US 27/SR 1 - HAMILTON ROAD WIDENING
Project No. NH-017-1(20)
P.I. No. 322250
Troup County

Value Engineering Study Report
Preliminary Design Submittal

December 2007

P-1/A-1
40

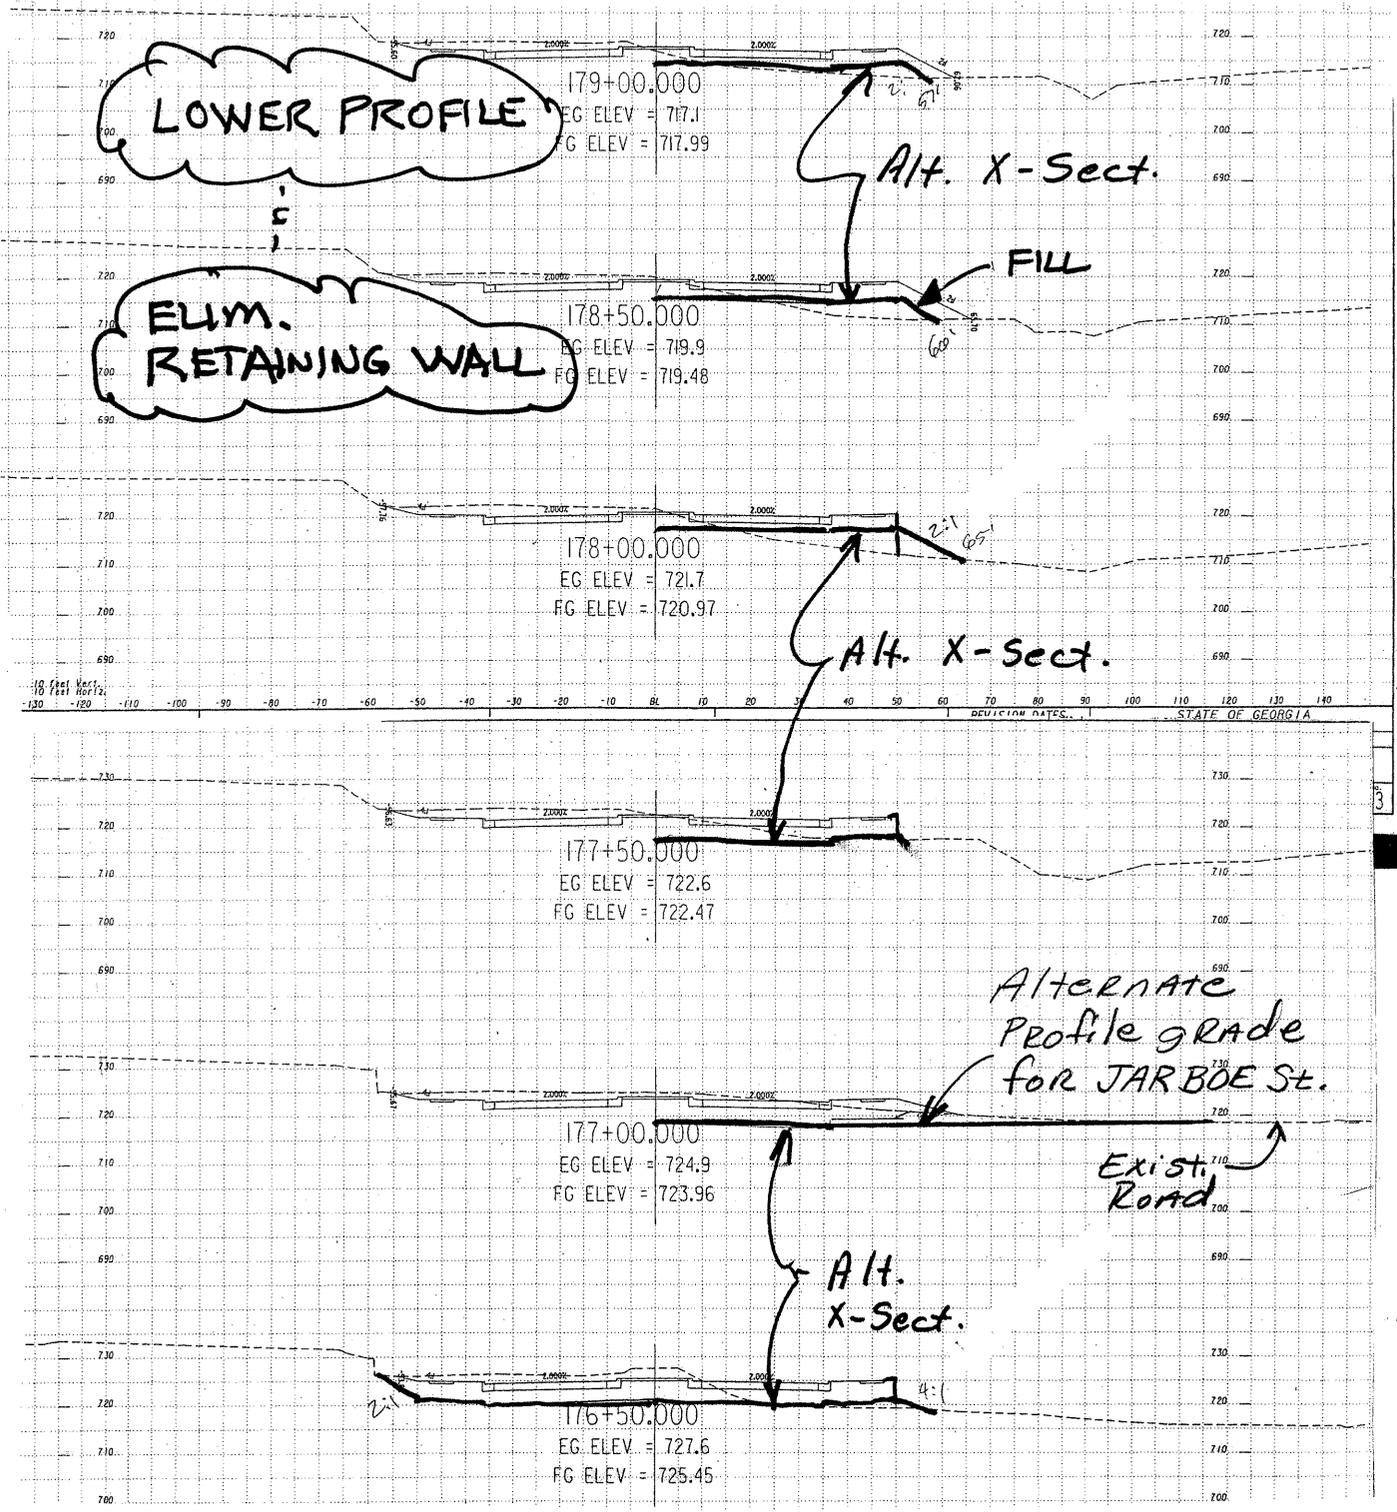
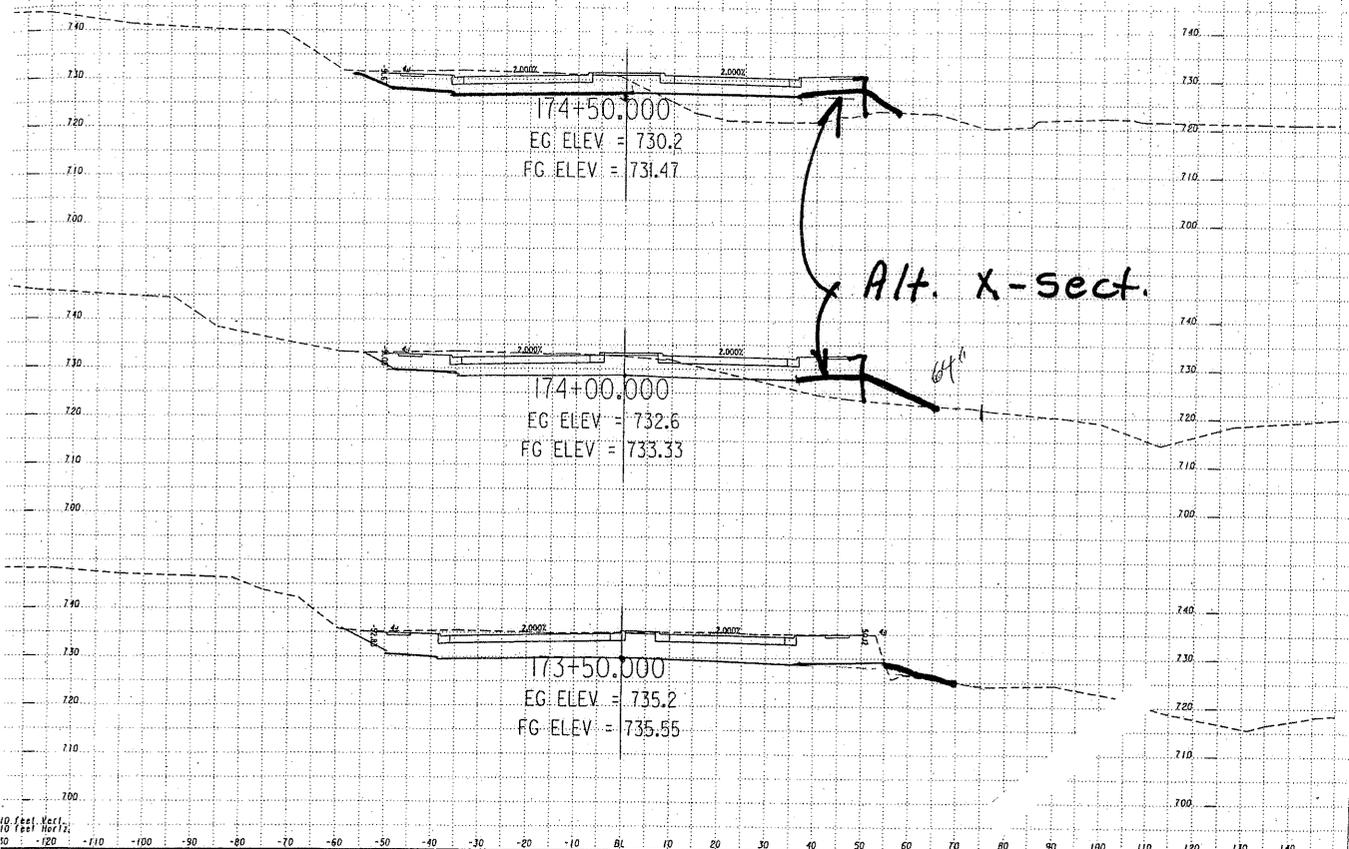
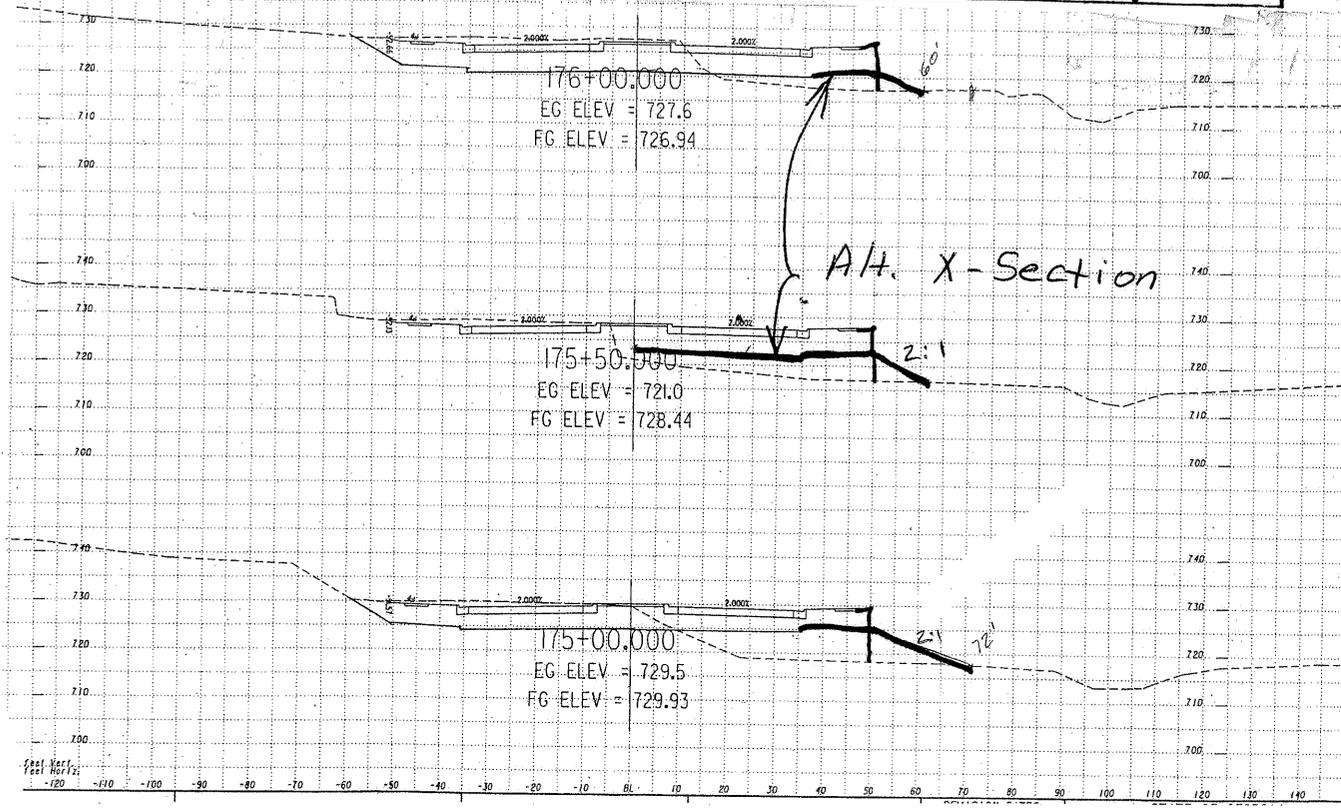
NOTES:
 • DELETE RETAINING WALL
 • LOWER PROFILE

ALTERNATIVE NO.: P-2

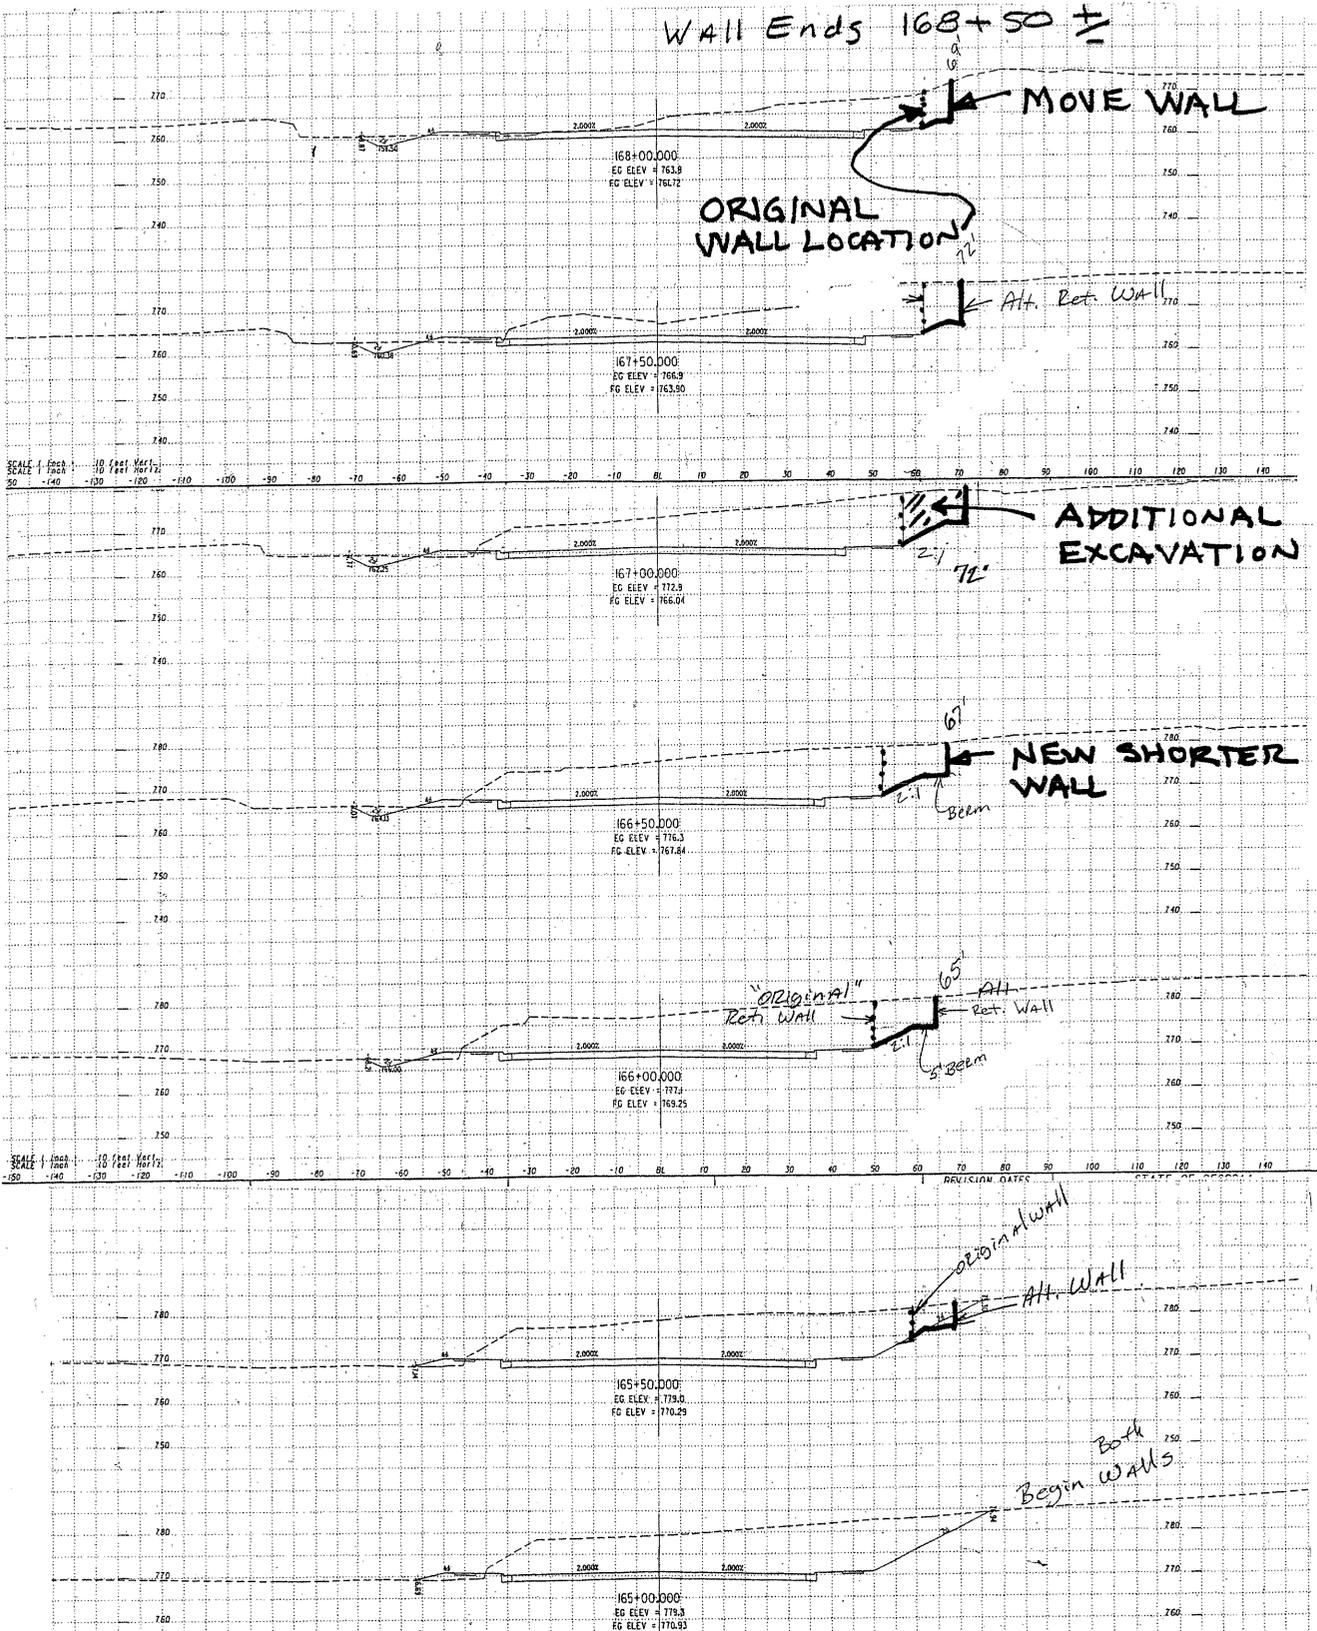
This alternative proposes to use both a 2:1 back slope and retaining wall on a berm to reduce the height of the retaining wall. Even though this design offsets the retaining wall more, most of the wall would be located on “remnant” parcels. This design requires slightly more right-of-way (1,000 SF) and excavation (800 CY). However, the savings in the retaining wall height would reduce the construction cost by at least \$80,000 and most likely more due to reduced construction time.

ALTERNATIVE NO.:
S-2

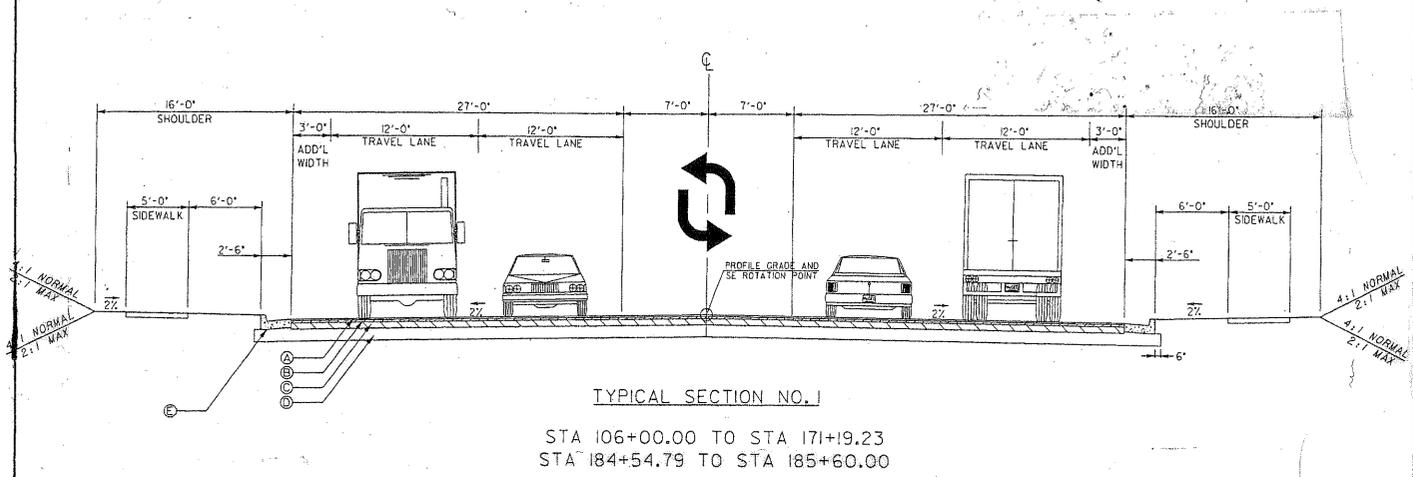
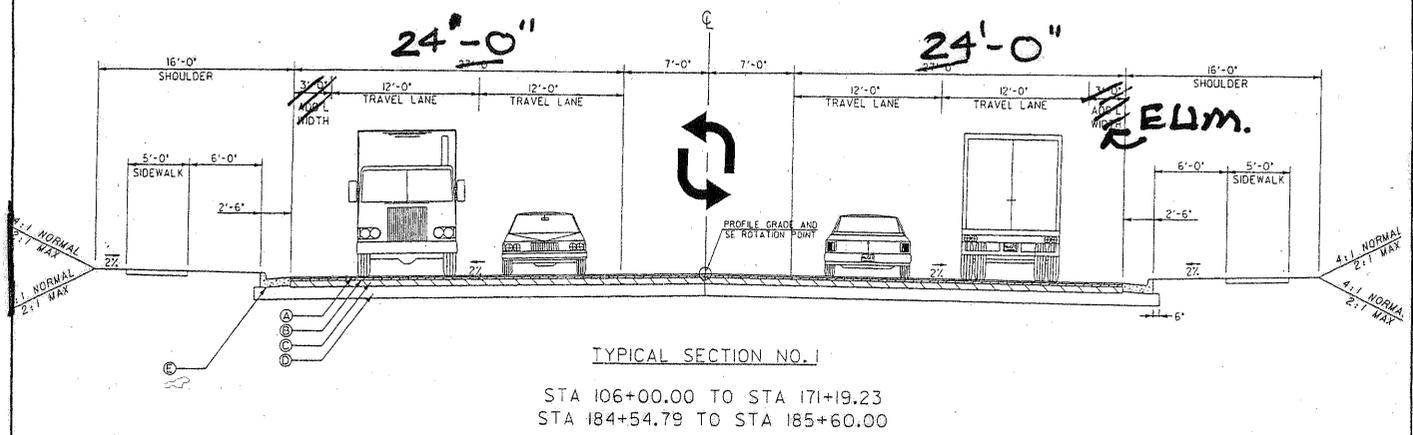
DESCRIPTION: **DELETE 3 FT. OF PAVEMENT (OUTSIDE CURB LANE) IN EACH DIRECTION, BUT MAINTAIN 12-FT. TRAVEL LANES**

From Station 185+60 onward, no 3 ft. of additional pavement width is provided unless bike lanes are planned in the future. Savings in construction and right-of-way costs should be achieved by eliminating 6 ft. (3 ft. + 3 ft.) of pavement.

ALTERNATIVE NO.:
S-4

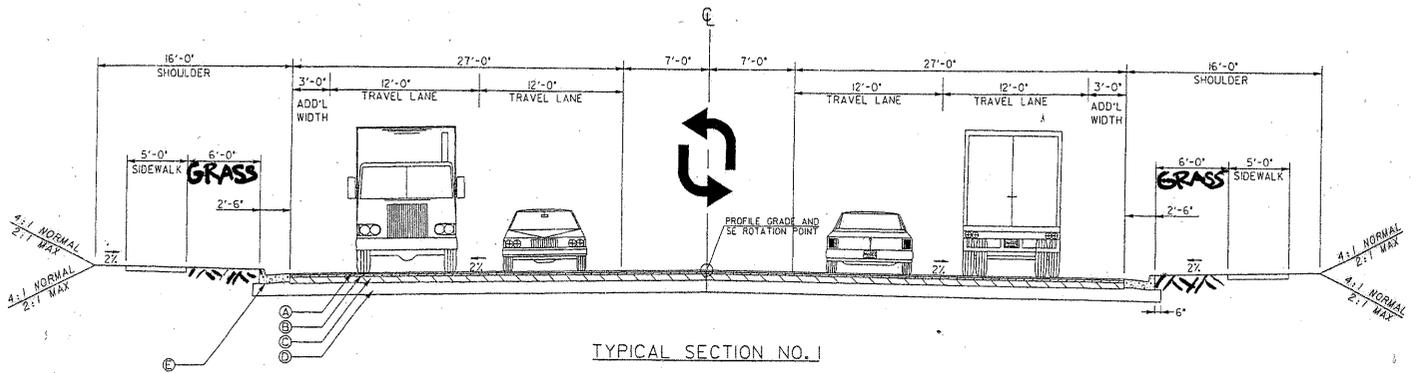
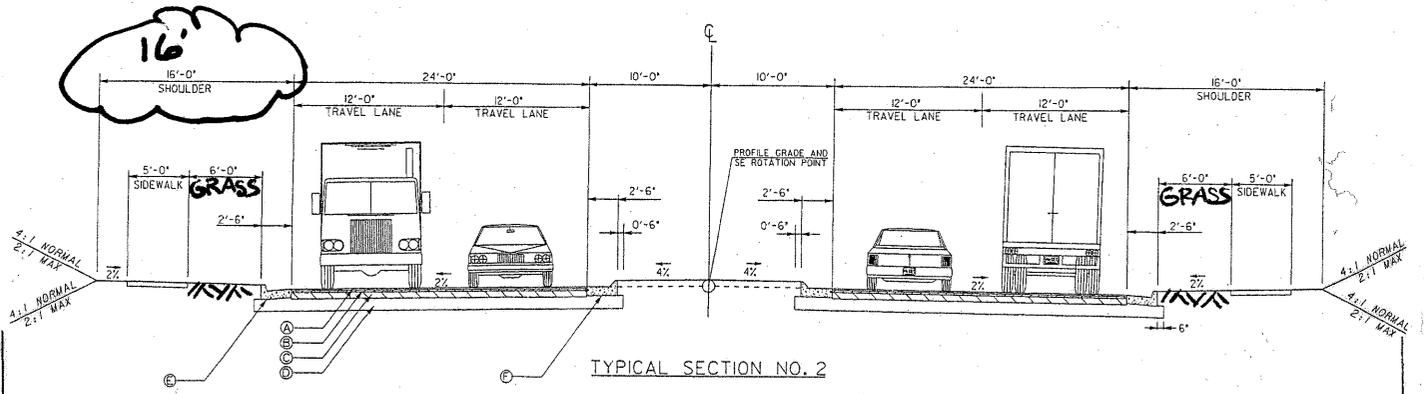
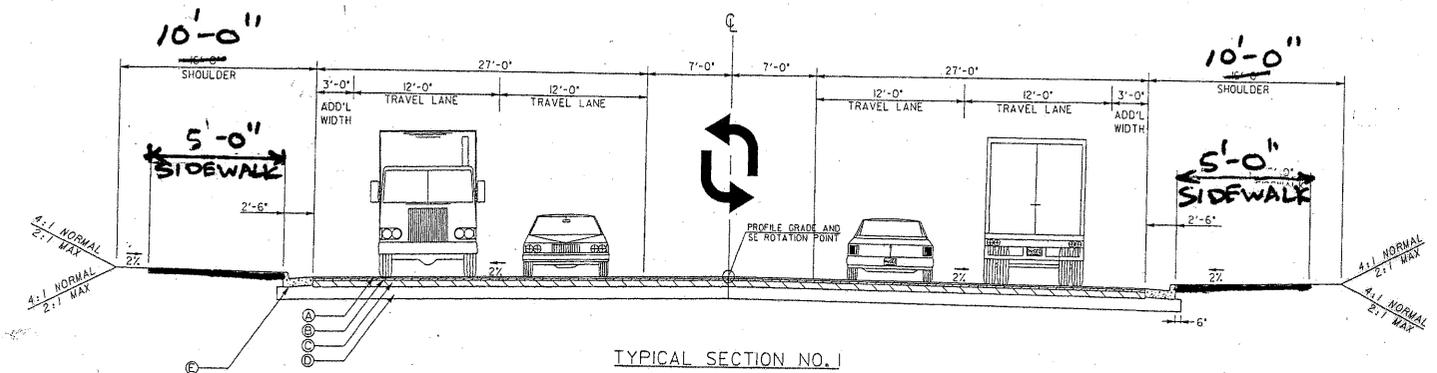
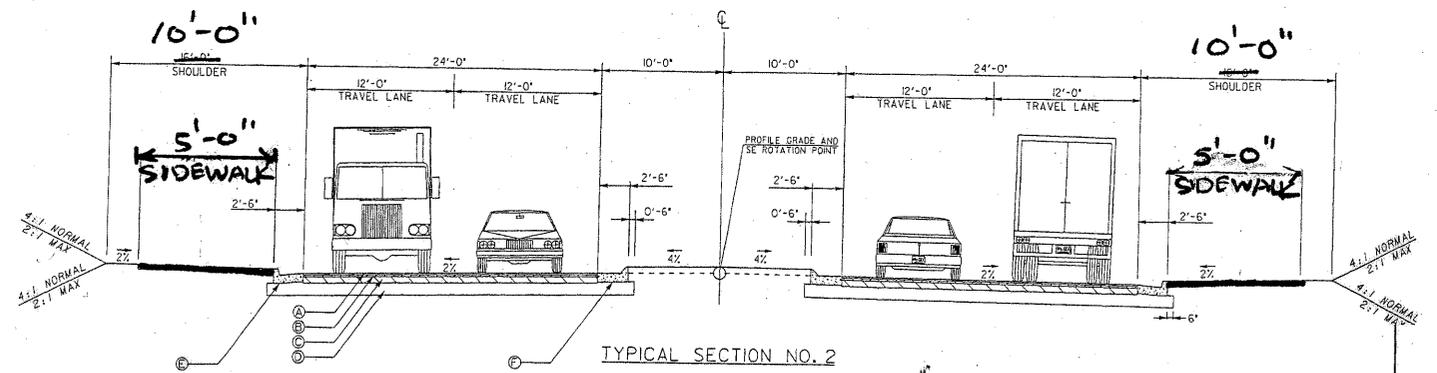
Six ft. of grass between the sidewalk and curb creates perpetual maintenance. It is best not to provide such a strip and save money by reducing the right-of-way requirement.
